## INVITATION TO BID #2017-51 ACCESS GATES AND SUPPORTING CONDUITS AT TRI-CITY SERVICE DISTRICT AND KELLOGG CREEK WATER RESOURCE RECOVERY FACILITIES ADDENDUM NUMBER 1 July 19, 2017

Addendum #1 Notes

Revised Drawing No. E-2 7-19-17

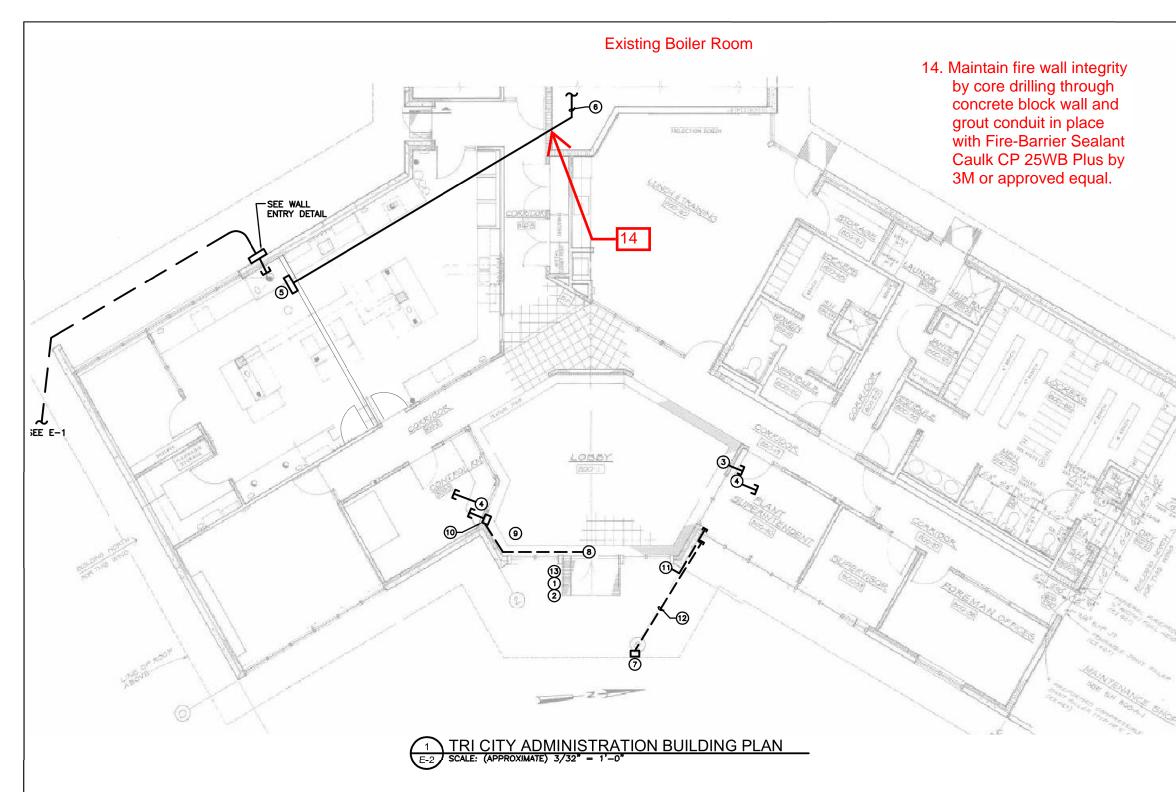
- 1. The following items are to be added to the Project Information, Plans, Specifications and Drawings, hereby attached and included by reference:
  - a. ACCESS GATES AND SECURITY SYSTEM CERTIFICATE OF ENGINEER-Dated June, 2017
  - b. Drawing No. E-4: TRI CITY LAB BUILDING SECURITY PLAN
- 2. Remove and replace Drawing No. E-2 with the attached Revised Drawing No. E-2 Addendum #1 Notes, dated 7-19-17.
- 3. Add the following to Drawing No. C-2, Key Note 12: *Remove grass and soil to a depth of* 3" below the triangular area between existing and new concrete fence pad. Fill area with new bark mulch as approved by Owner.
